UNITED STATES  
DEPARTMENT OF THE INTERIOR  
BUREAU OF LAND MANAGEMENTFORM APPROVED  
OMB NO. 1004-0135  
Expires July 31, 2010**SUNDRY NOTICES AND REPORTS ON WELLS**  
*Do not use this form for proposals to drill or to re-enter an abandoned well. Use form 3160-3 (APD) for such proposals.***SUBMIT IN TRIPLICATE - Other instructions on reverse side.**

1 Type of Well <input type="checkbox"/> Oil Well <input checked="" type="checkbox"/> Gas Well <input type="checkbox"/> Other		5 Lease Serial No NMSF080243
2 Name of Operator BP AMERICA PRODUCTION CO.		6 If Indian, Allottee or Tribe Name
Contact CHERRY HLAVA E-Mail: hlavac@bp.com		7 If Unit or CA/Agreement, Name and/or No NMNM73113
3a Address 200 ENERGY COURT FARMINGTON, NM 87401	3b Phone No. (include area code) Ph: 281.366.4081	8 Well Name and No RIDDLE A 3
4 Location of Well (Footage, Sec., T., R., M., or Survey Description) Sec 18 T30N R9W NENE 0915FNL 1155FEL 36.816437 N Lat, 107.816025 W Lon		9 API Well No 30-045-11791-00-S1
		10 Field and Pool, or Exploratory BLANCO PICTURED CLIFFS
		11 County or Parish, and State SAN JUAN COUNTY, NM

BP finds no further potential for this well and respectfully requests permission to plug the ent

# Proposed WBD

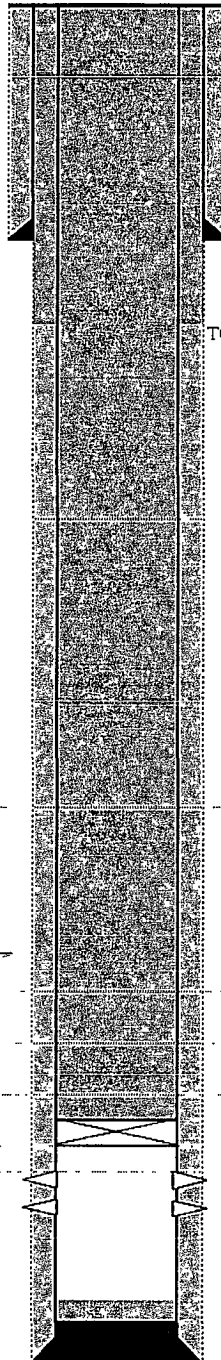
\* Run CBL and provide results to agencies prior to beginning plugging operations

\*\* BLM REVISED \*\* BLM REVISED \*\* BLM REVISED \*\* BLM REVISED \*\* BLM REVISED \*\*
